ADDENDUM No. 1

REQUEST FOR QUOTATIONS No.: 1220-040-2017-012

TITLE: SOUTH SURREY WATER PARK

ADDENDUM ISSUE DATE: January 9, 2017

DRAWING 7.1
E10 INSTALLATION DRAWING

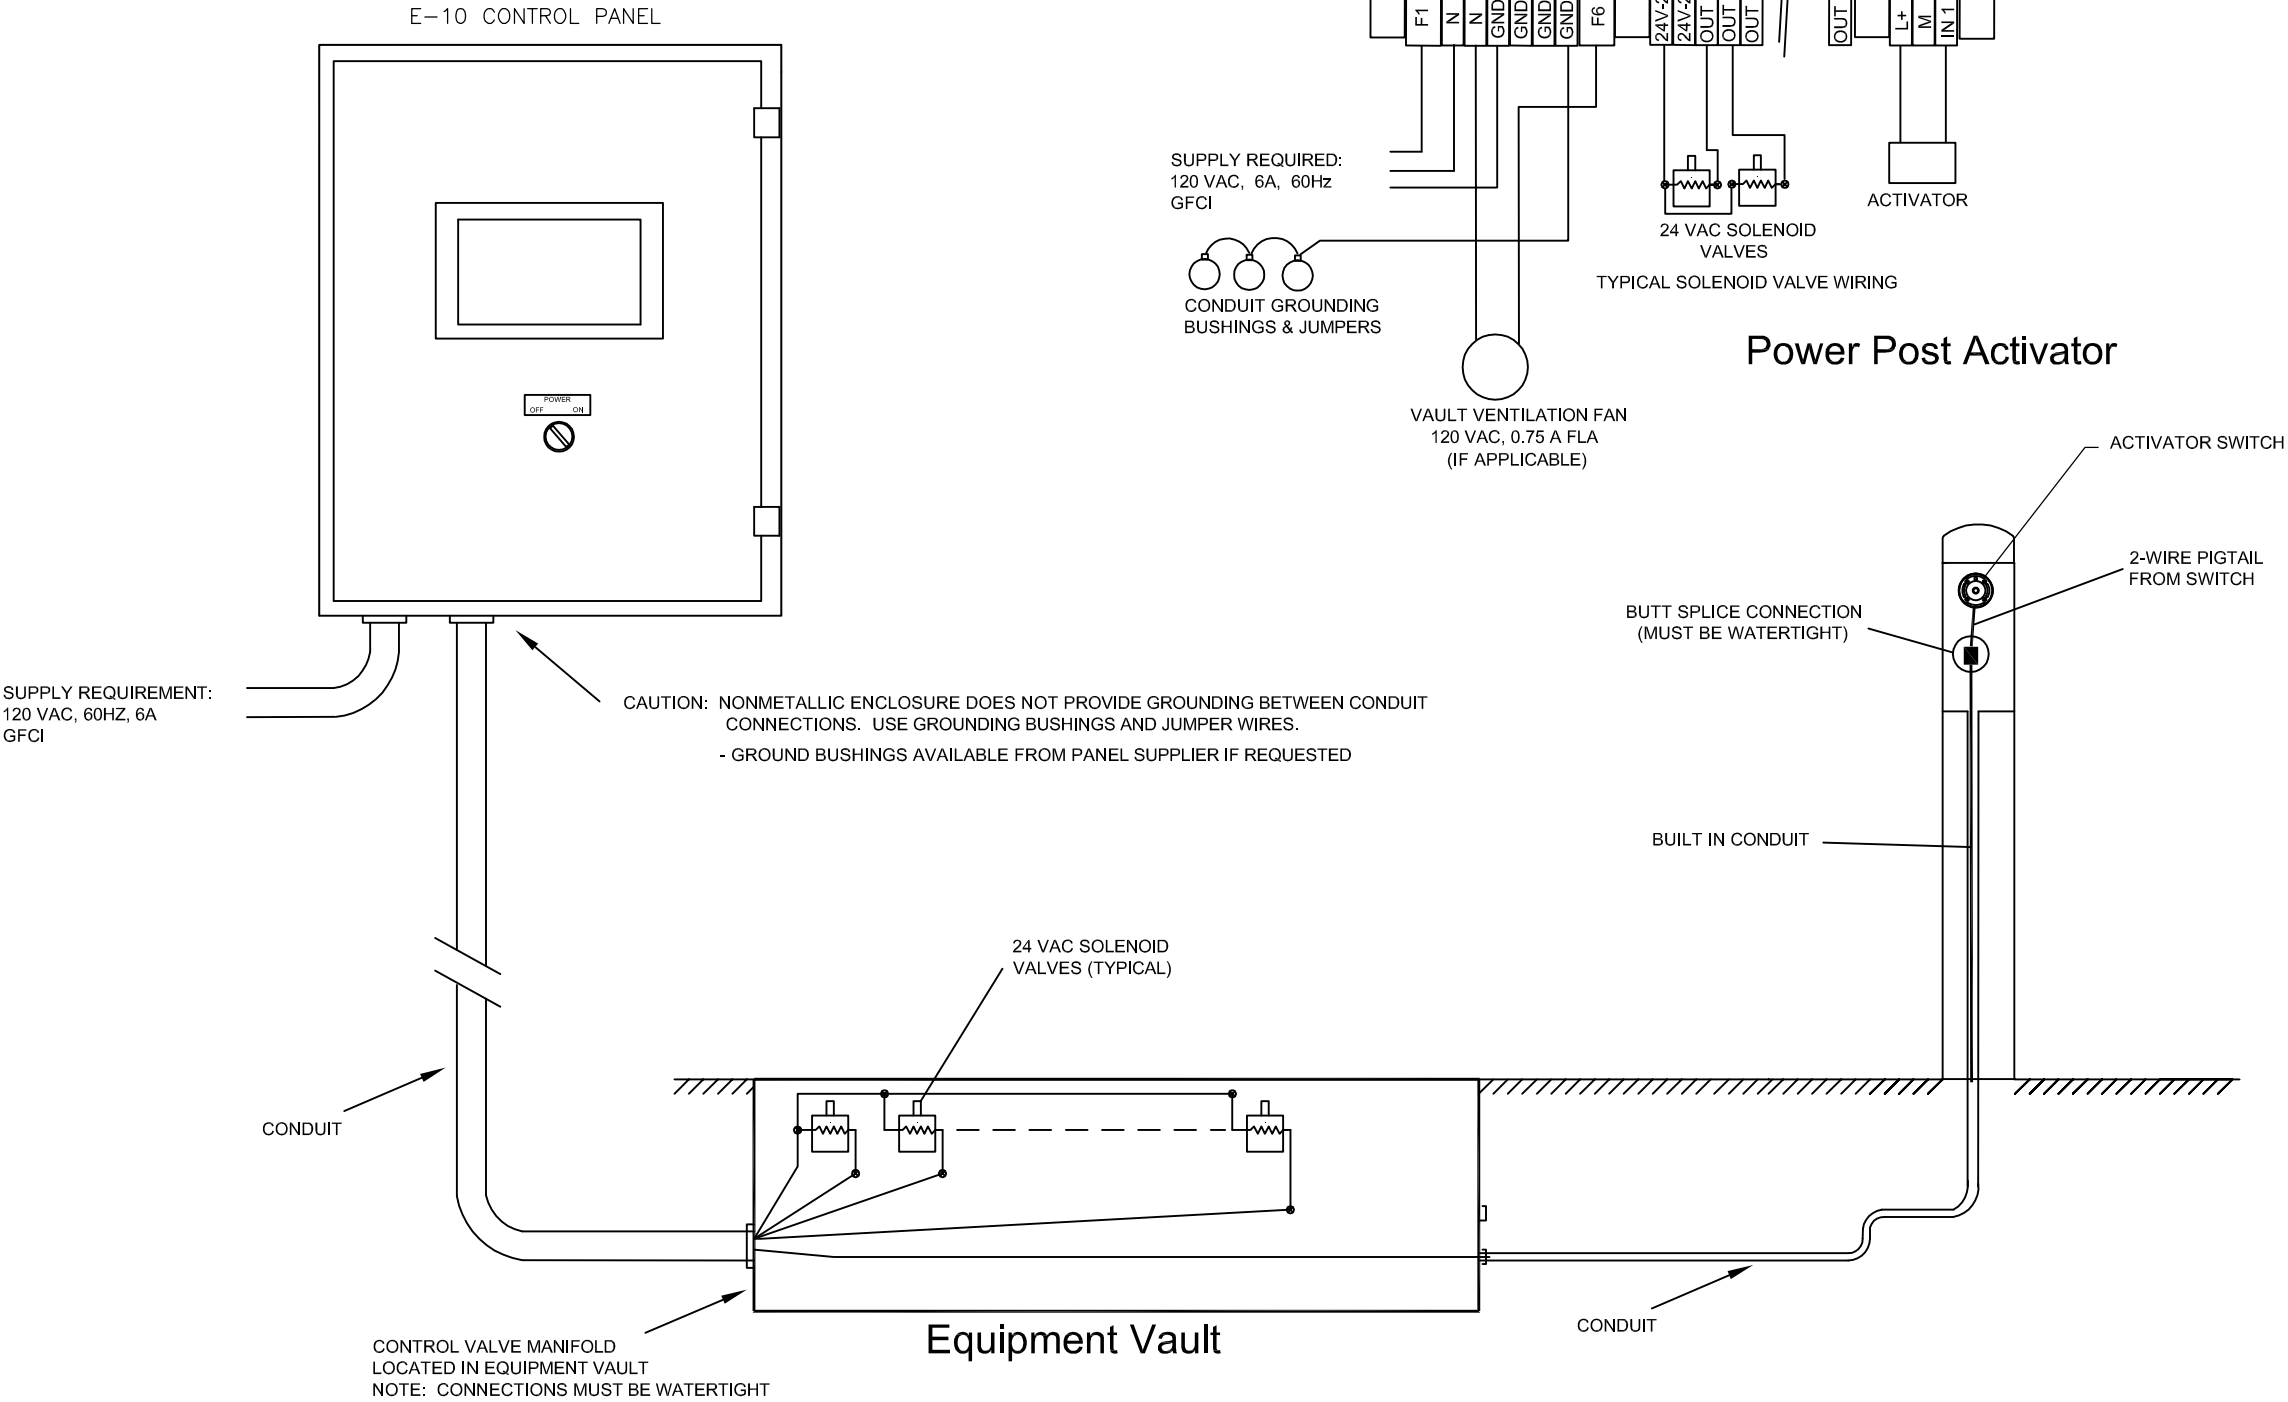
Q5: What are the wiring requirements for the solenoid valves mounted on the manifold?

A5: Solenoid valves require minimum 14 AWG wiring. The attached generic E-10 installation drawing shows typical valve wiring with a common 24V wire too each solenoid valve, and wiring from each solenoid to its corresponding output.

E-10 FIELD AND CONTROL WIRING DIAGRAM

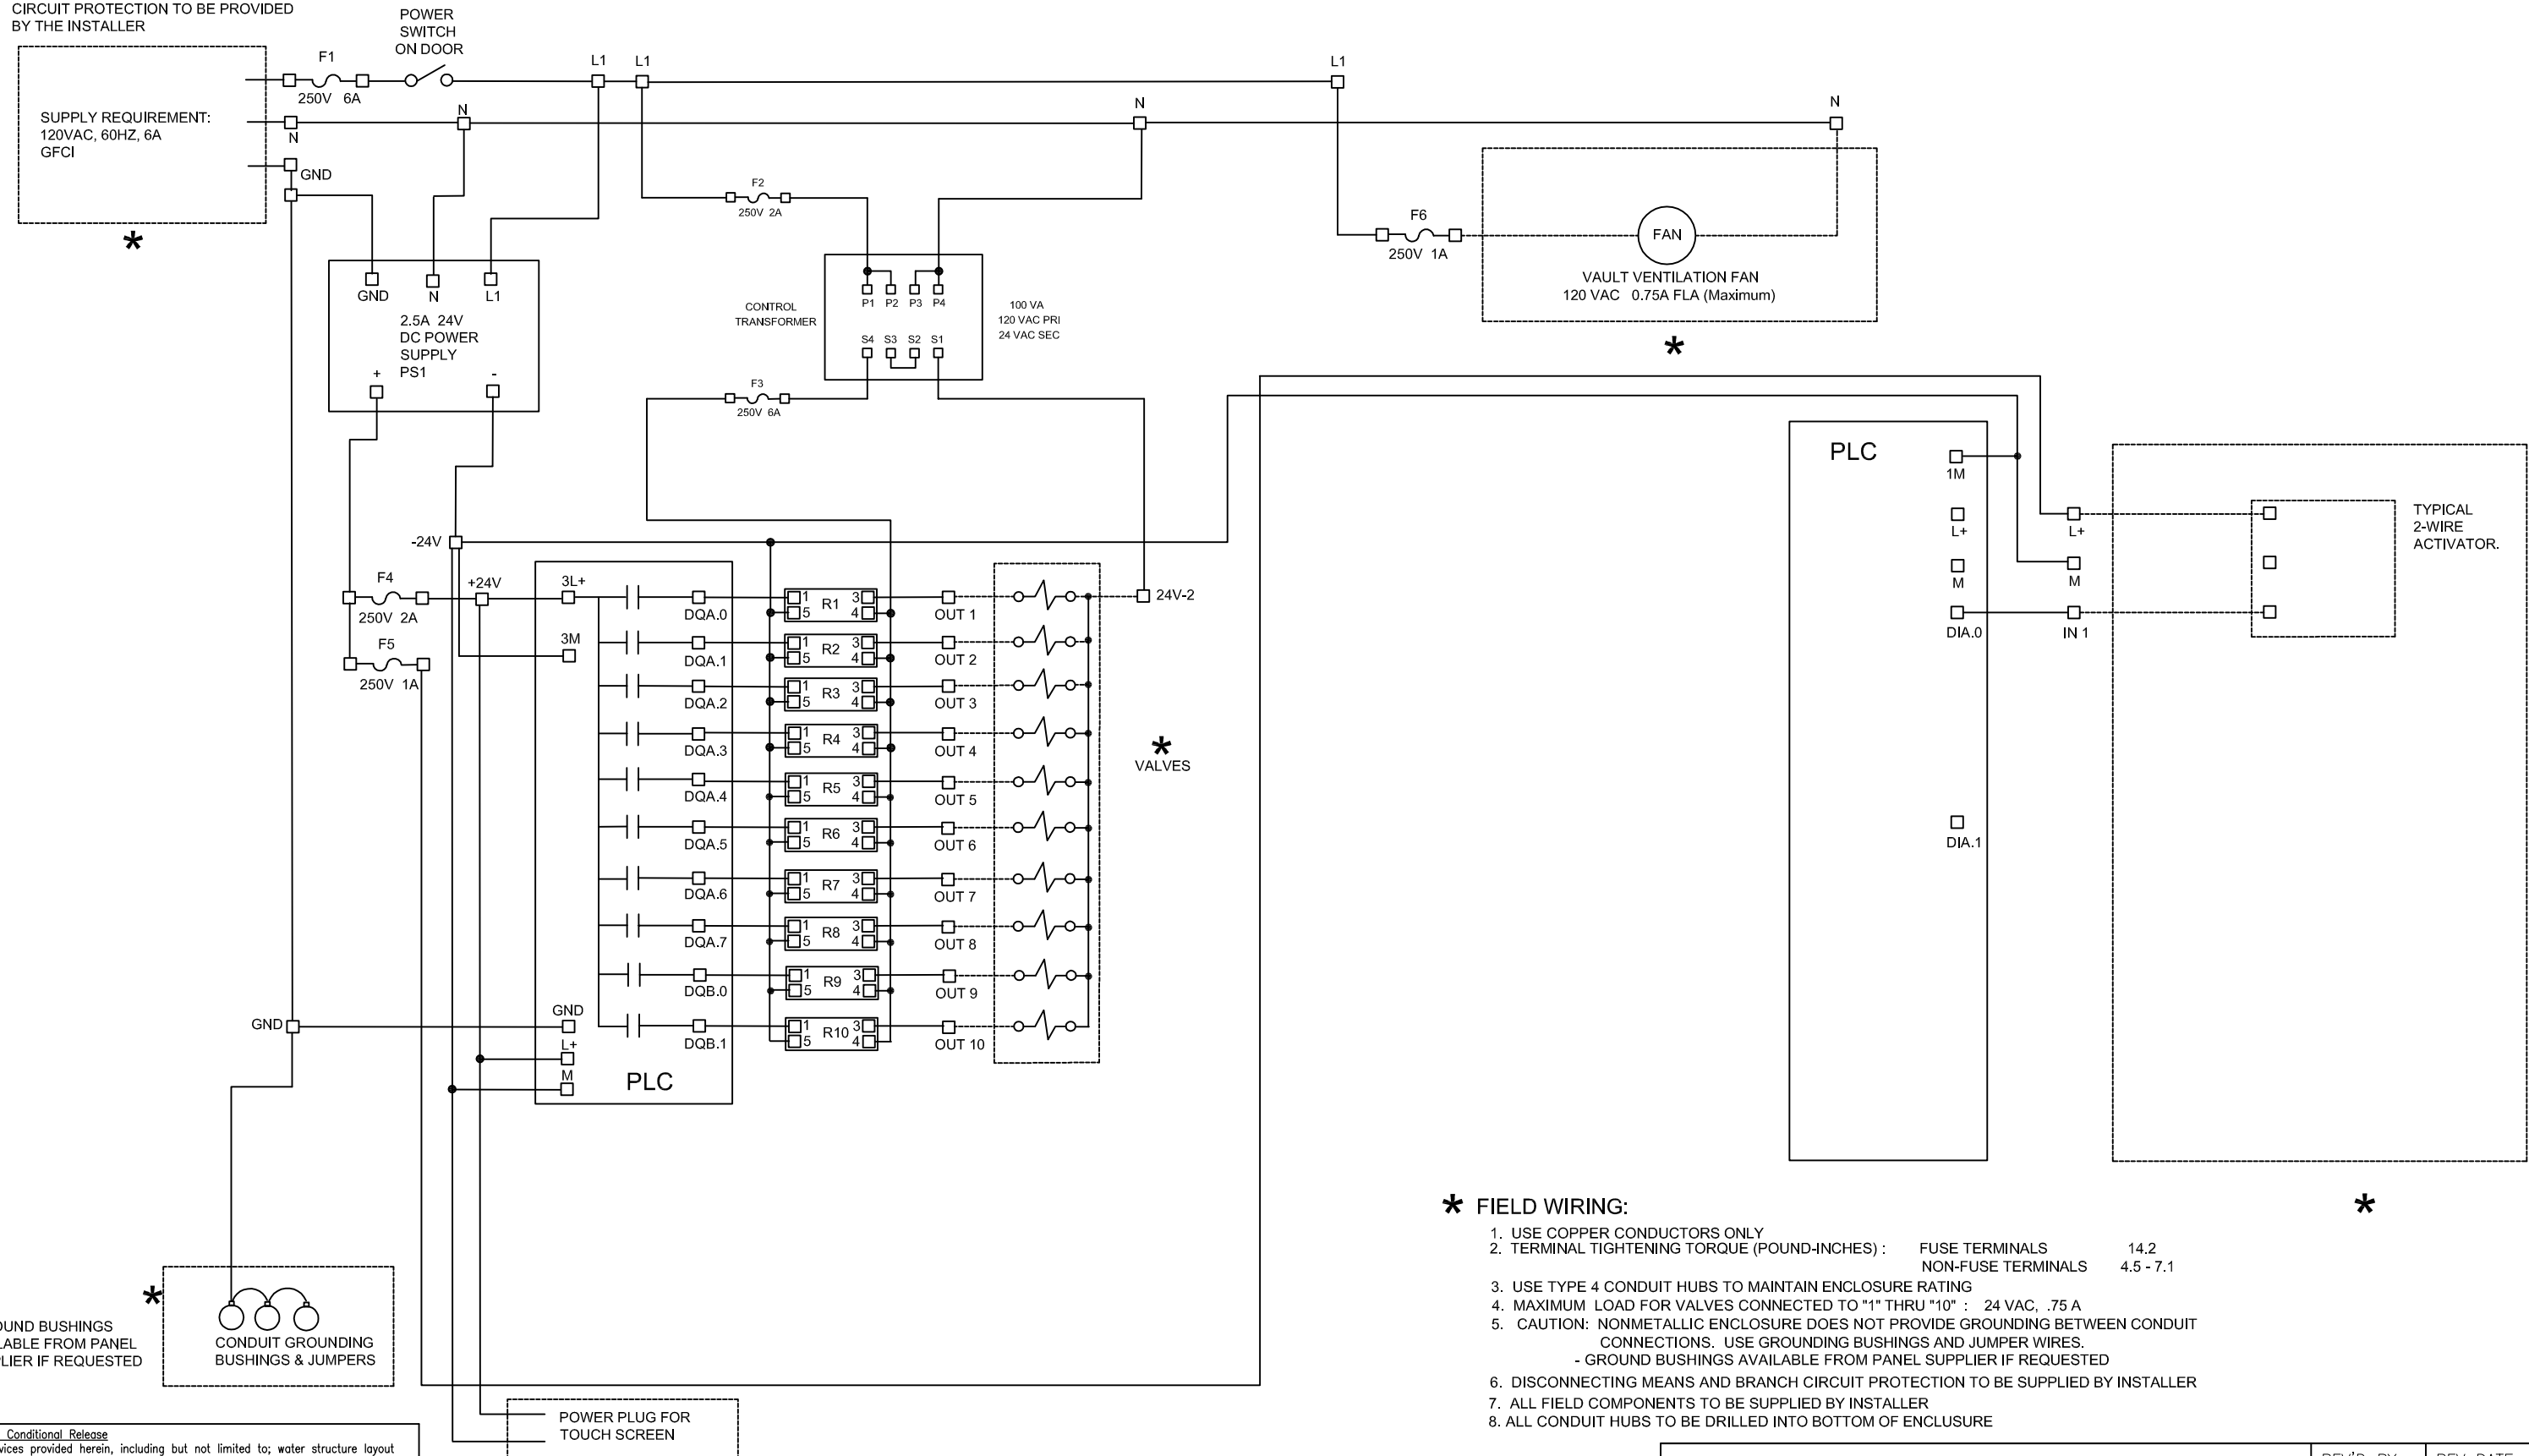
Q4: Is there a wiring diagram for the Power Post Activators?

A4: Once the controller is built, Waterplay will have a project specific wiring diagram detailing the wiring connections for the activators at the controller. Attached are generic wiring diagrams which show activator input(s) at the control panel field terminal strip. One wire runs from L+ (24v out), and the second from IN1 (activator 1), IN2 (activator 2), IN3 (activator 3).

WW E-10 CONTROLLER, STD, POTABLE

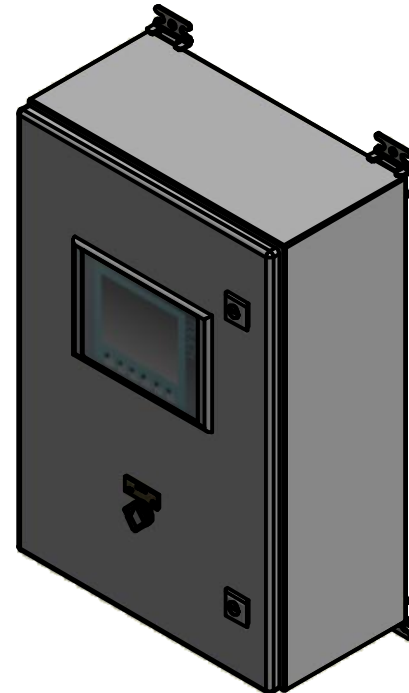
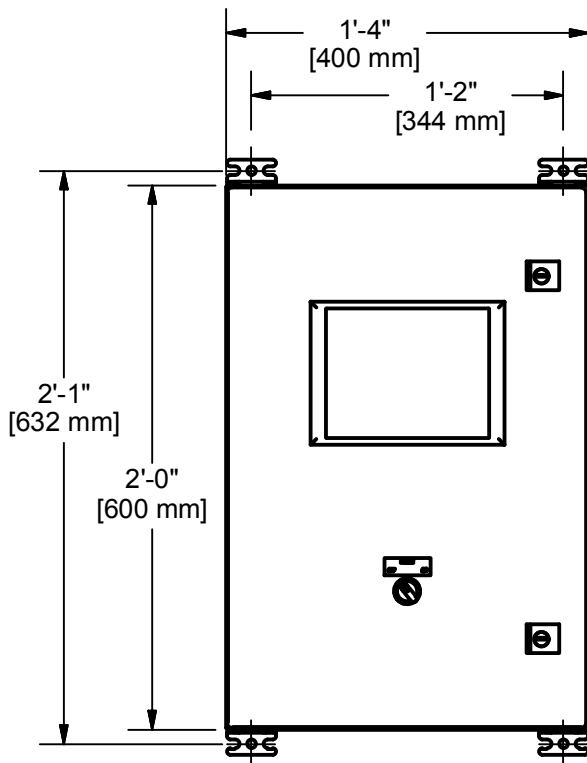
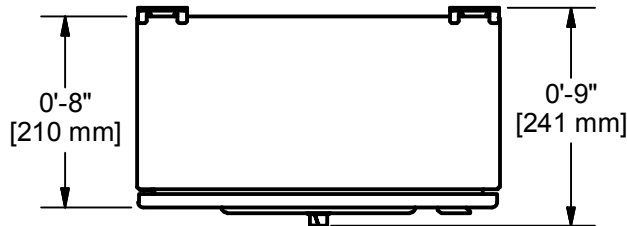
Q3: What kind and size of wire is required from the Control Panel to the Post Activators?

A3: Each activator requires a minimum 18 AWG 2-wire conductor w/ ground.
